DECISION OF THE PLANNING ADMINISTRATOR

PARTITION CASE NO.: PAR20-04

NOTICE OF DECISION DATE: APRIL 10, 2020

TENTATIVE PARTITION PLAN FOR ZACHARY JASON ZEEK

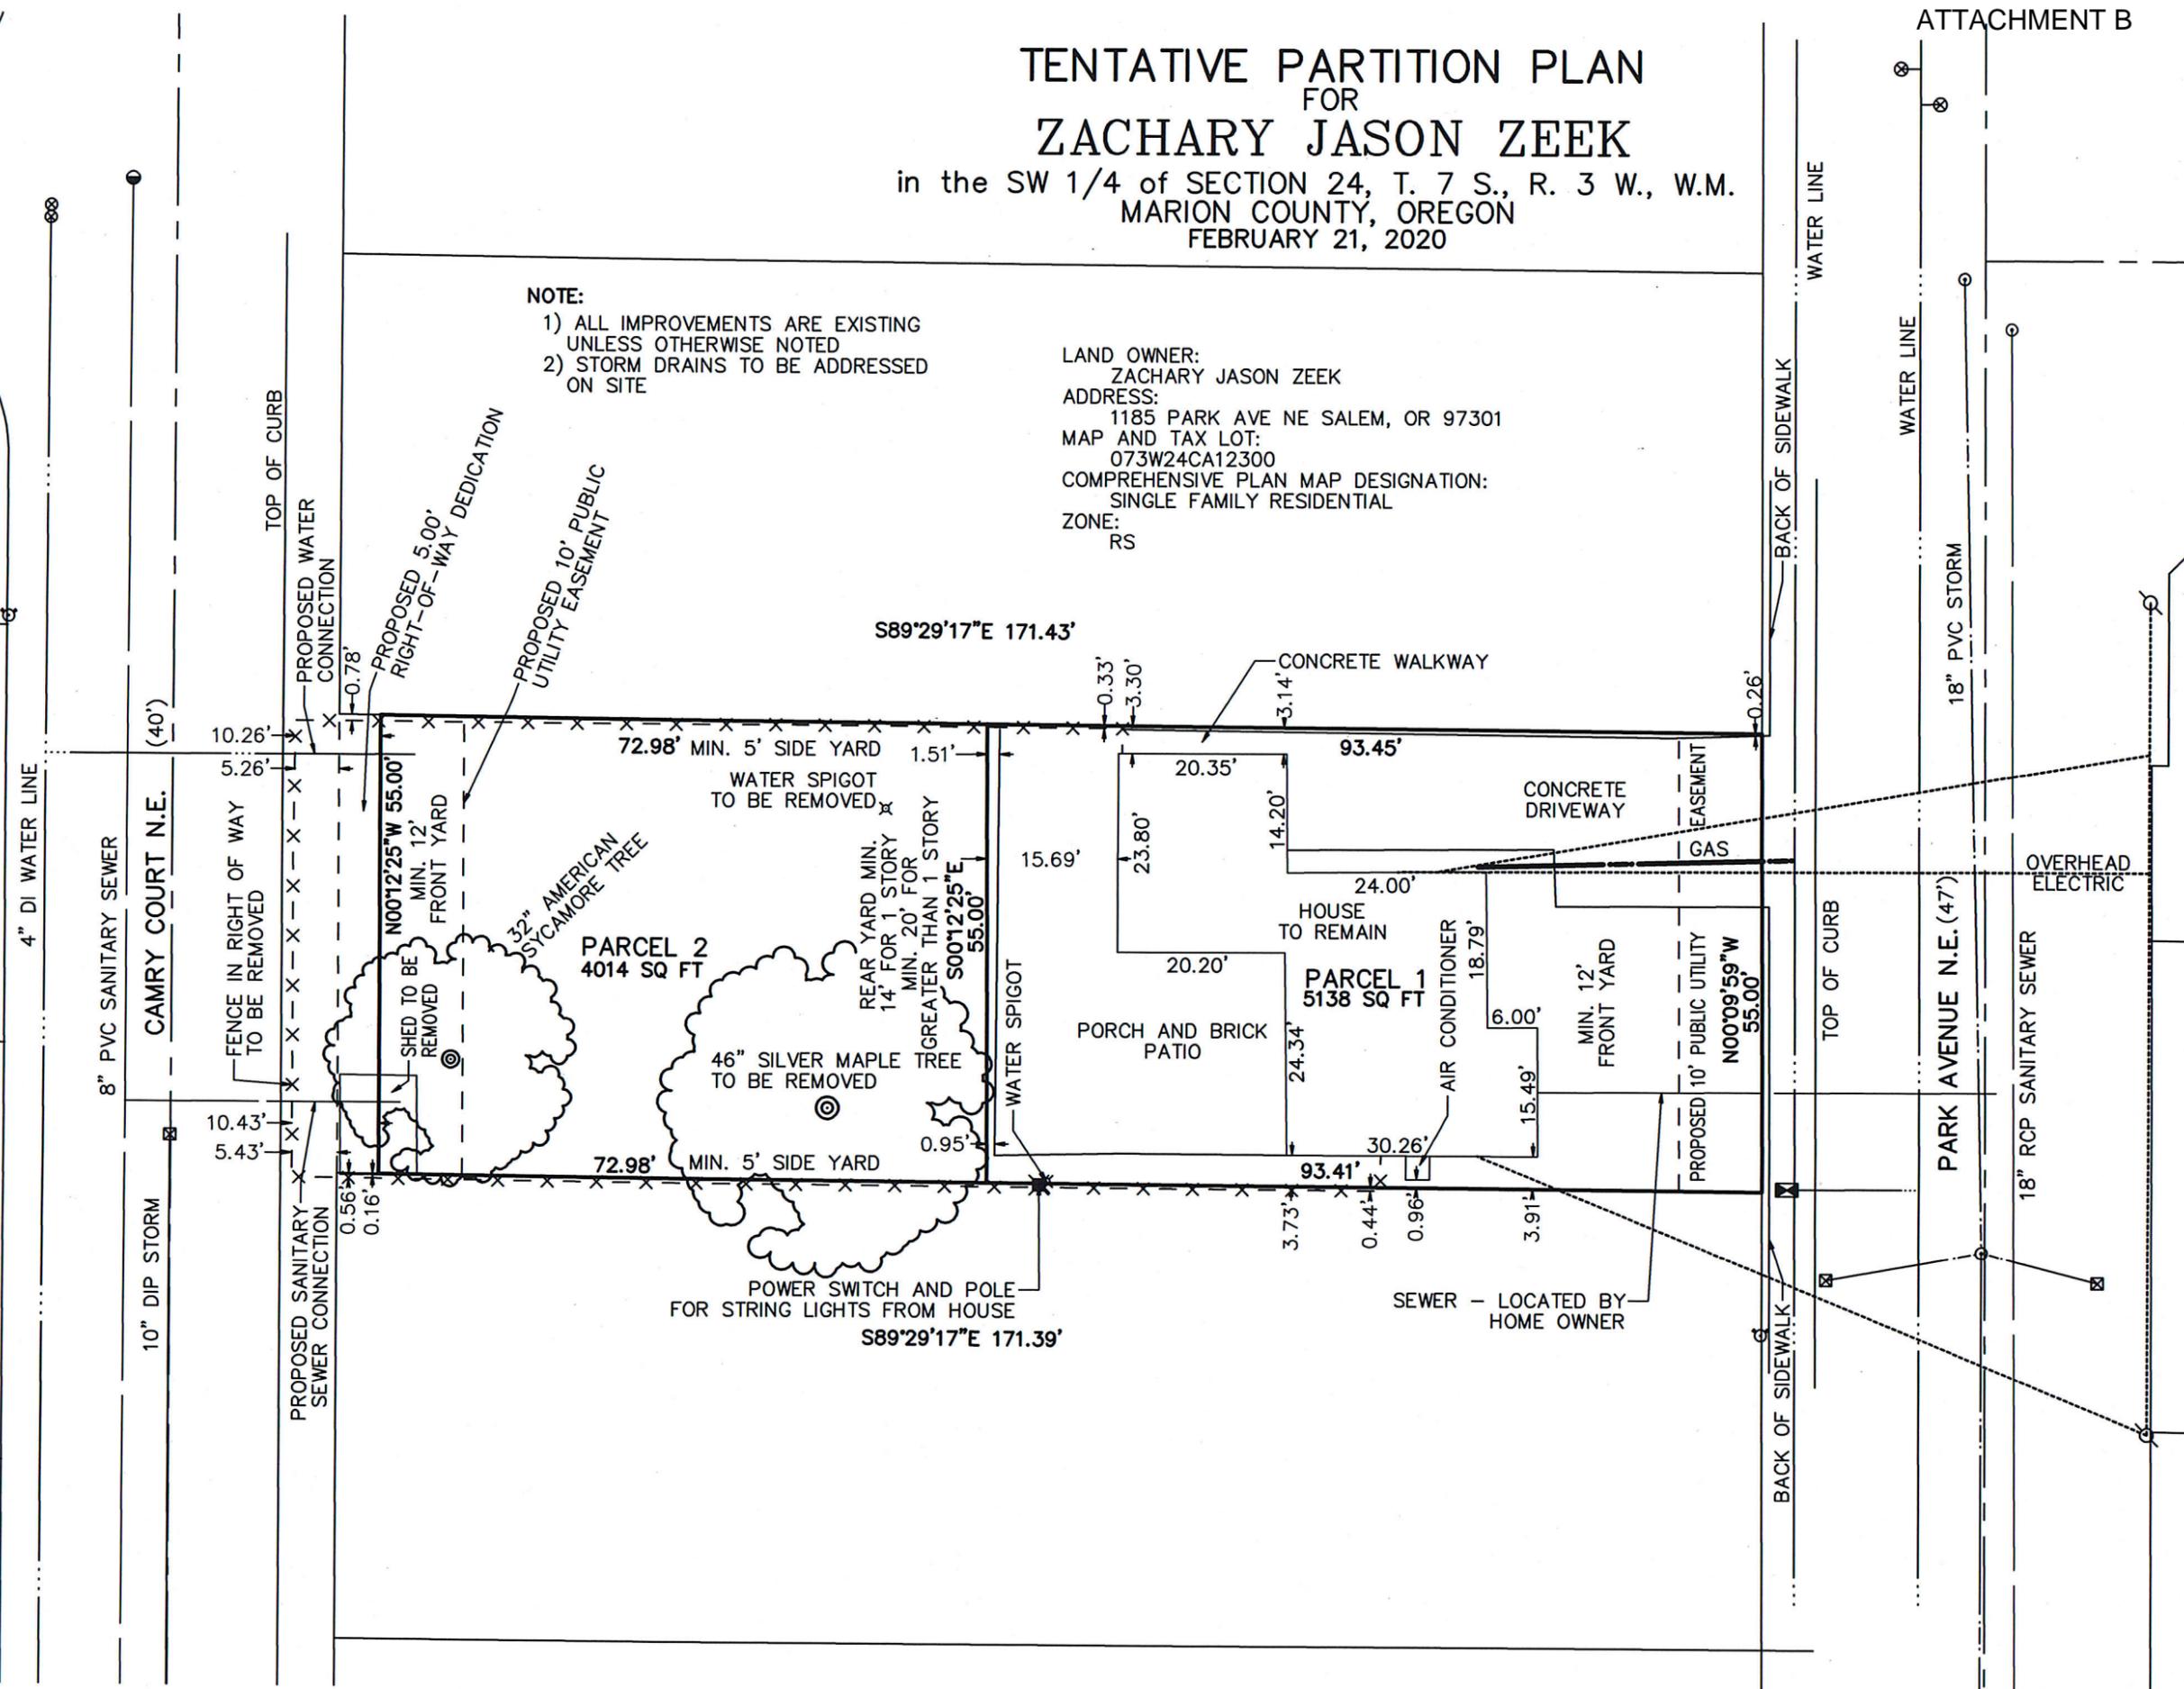
Setback requirements for proposed Parcel 2 will be reviewed at the time of application for building permits. The proposed partition plan provided by the applicant notes future building setbacks. The existing detached accessory structure on proposed Parcel 2 does not meet minimum setbacks abutting a street, and the applicant has proposed to remove it. Condition 2, below, requires removal of the accessory structure because the accessory structure is not permitted on a parcels without a main structure.

The tentative partition plan indicates a tall fence in right-of-way of Camry Court NE that extends into the front yard of proposed Parcel 2. The fence is adjacent to the curb and sight-obscuring. To ensure that the fence for proposed Parcel 2 is in conformance with the standards, the following condition is required:

SRC Chapter 802 (Public Improvements): Comments from the Public Works Department indicate that water and sewer infrastructure is available along the perimeter of the site and appears to be adequate to serve the proposed partition. Specifications for required public improvements are summarized in the Public Works Department memo dated March 31, 2020 (**Attachment D**).

Condition 2: Remove the accessory structure from proposed Parcel 2.

Condition 3: Remove the existing fence from the right-of-way of Camry Court NE as indicated on the tentative plan and comply with fence height and opacity standards within proposed Parcel 2.

Condition 4: Obtain permits for installation of water services to serve Parcel 2.

Condition 5: Construct sewer services that are proposed in the public right-of-way.

Condition 6: Design stormwater systems to serve all proposed parcels in compliance with PWDS. The stormwater systems shall be tentatively designed to accommodate future impervious surfaces on Parcel 2.
